## Review Comments

**Project:** Brighton Recovery Campus-Building B  
**Project No:** 20160686

**From:** Jason Worthen  
**Date:** March 20, 2017

### BUILDING B RESPONSES

# 1 FIRE ALARM PLAN - BUILDING 'B'

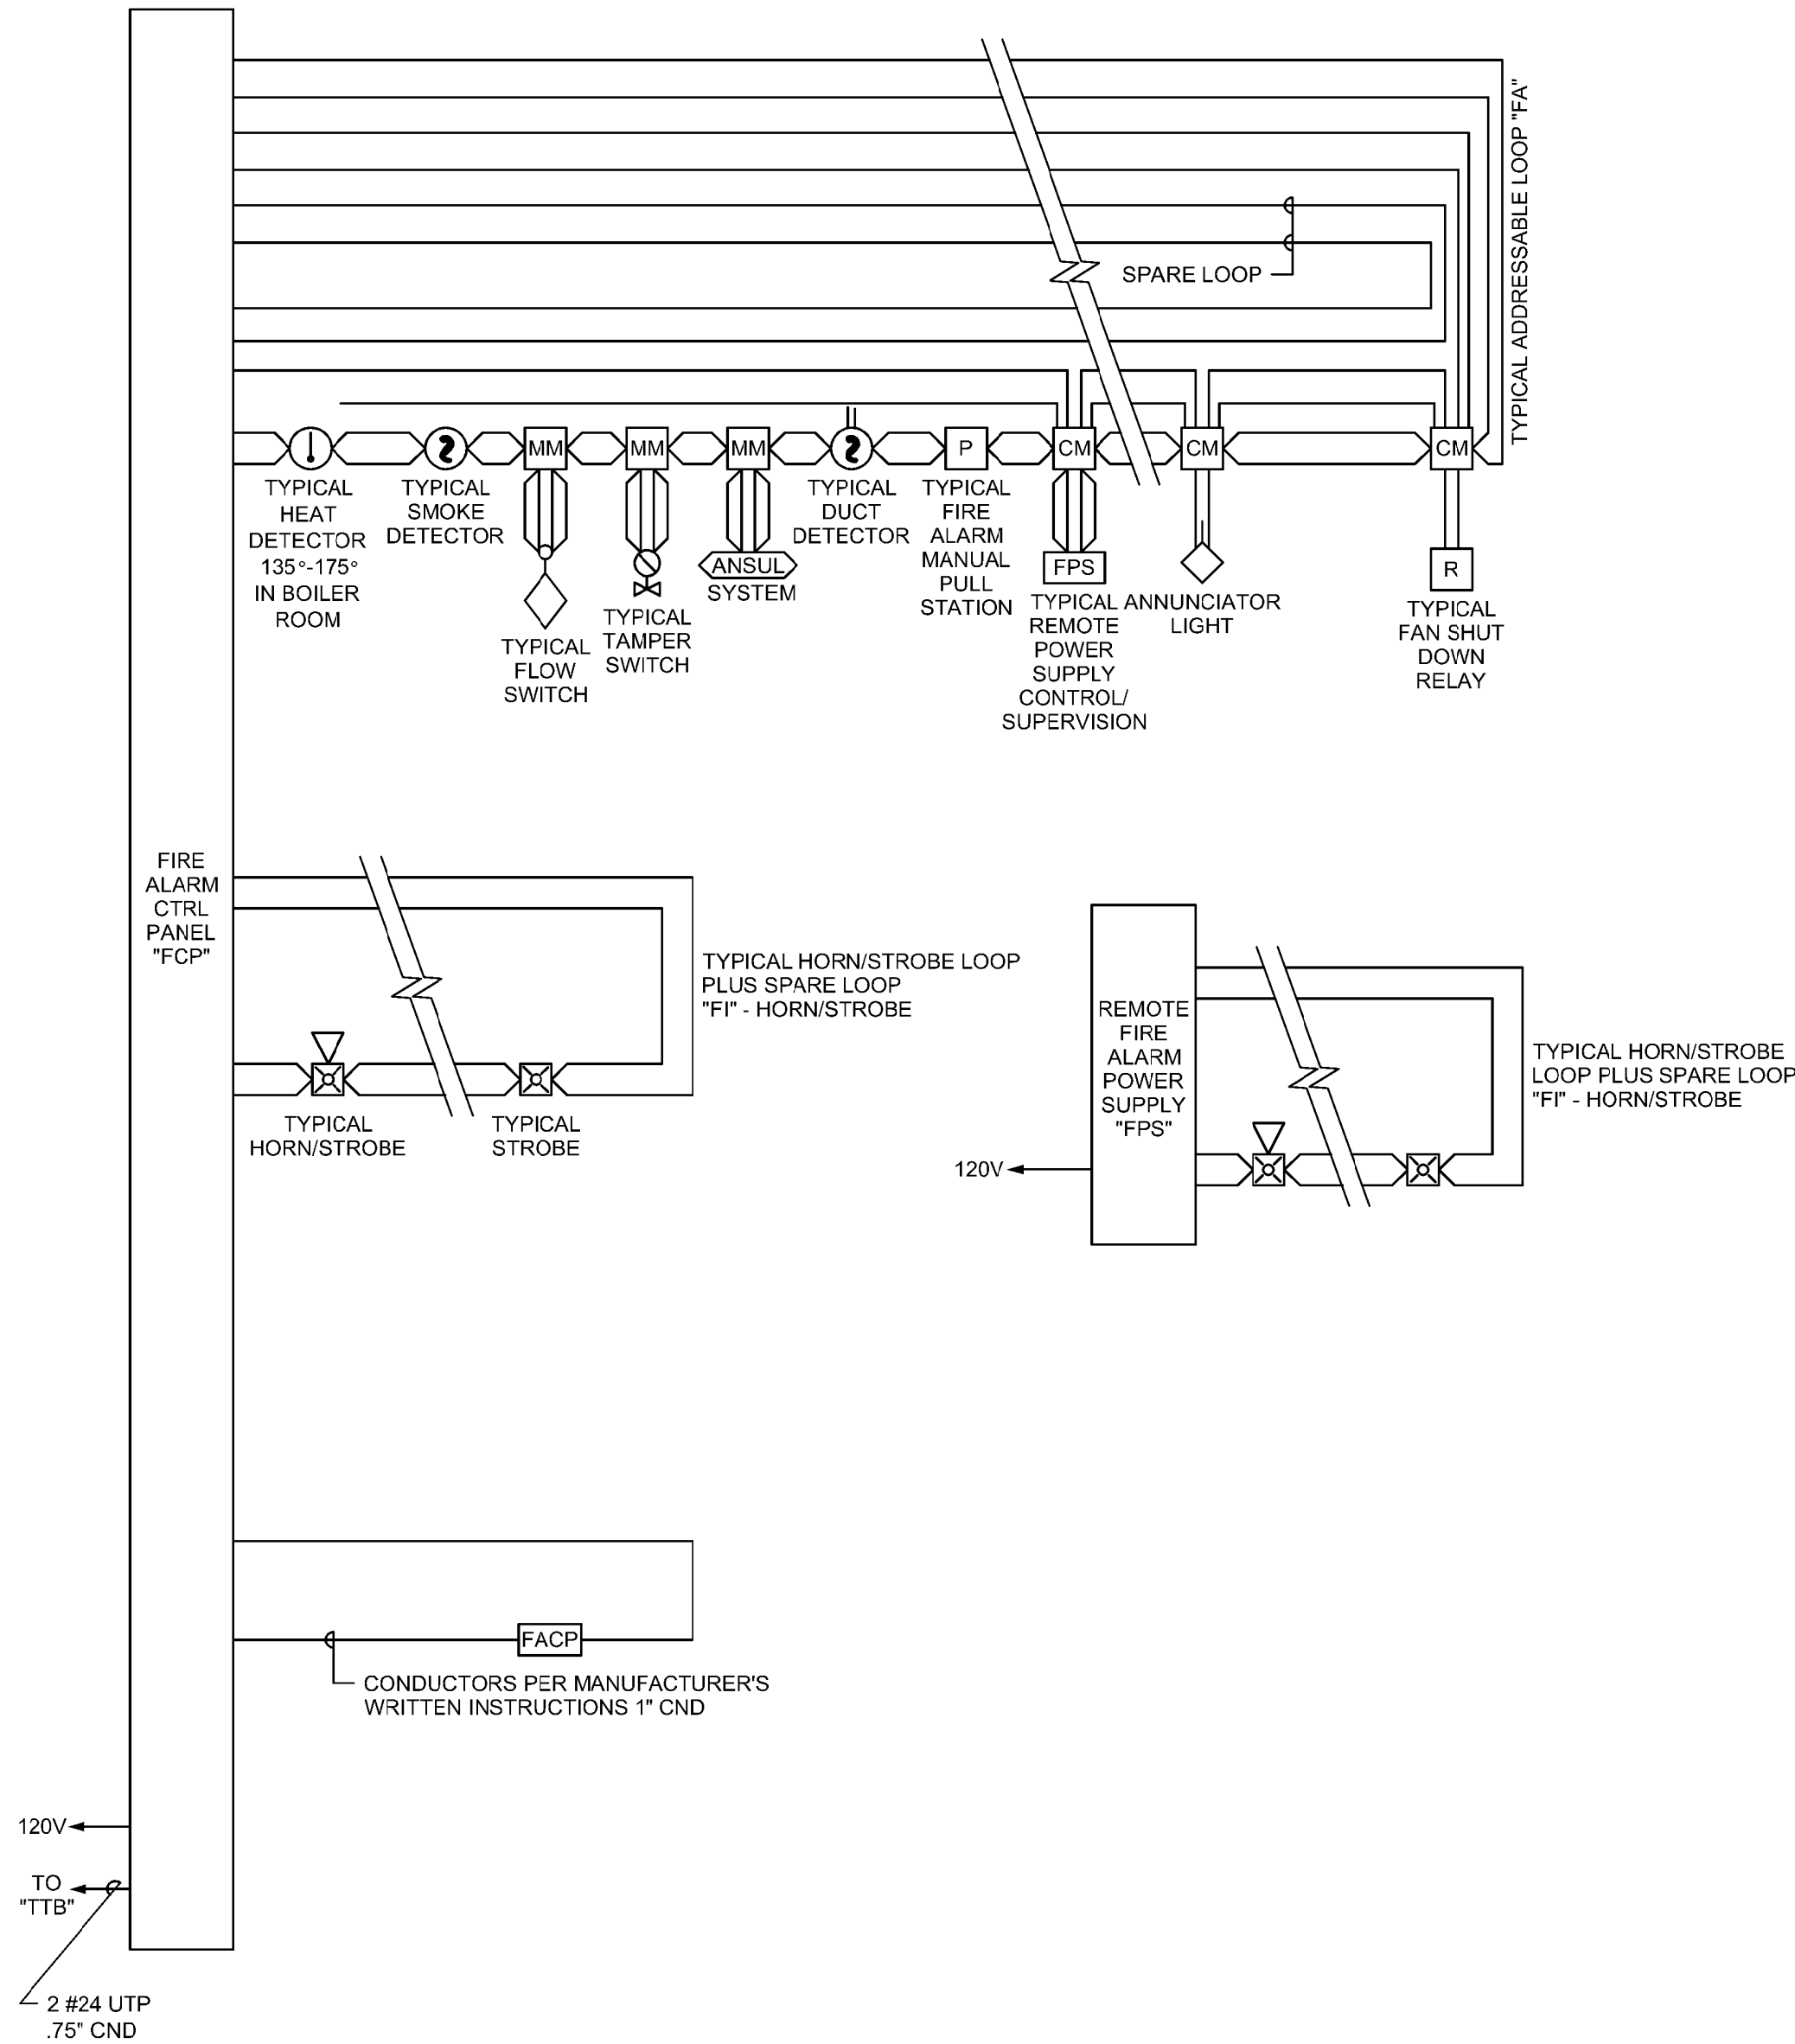
E1. IBC 907.2.11.5 requires that all smoke detectors be interconnected such that when one is activated it will activate all alarms.

E2. IBC 907.2.11.6 requires that smoke detectors receive their primary power from building wiring and that they are provided with battery backup.

E3. As amended by the State of Utah carbon monoxide detectors shall receive their primary power supply from the building and be provided with battery backup. Where multiple detectors are provided, they are required to be interconnected such that all will sound when any one is activated.

Response: Added the following note regarding the residential smoke detectors: "All residential smoke detectors and carbon monoxide detectors will be interconnected, will connect to a 120 volt building circuit and have battery backup. When one smoke detector is activated, all residential smoke detectors shall sound". Circuiting has been added to FA11B.

Response: Residential smoke detectors will receive power from building 120 volt circuit (Added circuiting on FA11B). Added general note to provide battery backup with detector.

Response: Added carbon monoxide detectors in common areas. Added note calling for all carbon monoxide detectors be provided with battery backup and be circuited/interconnected with residential smoke detectors such that all will sound when any one is activated.

2. Added a general note calling for all smoke detectors and carbon monoxide detectors to be interconnected, connected to a 120V circuit and have battery backup.
3. Added carbon monoxide detectors, one in each common area.

4. Added circuiting for residential smoke detectors and carbon monoxide detectors.
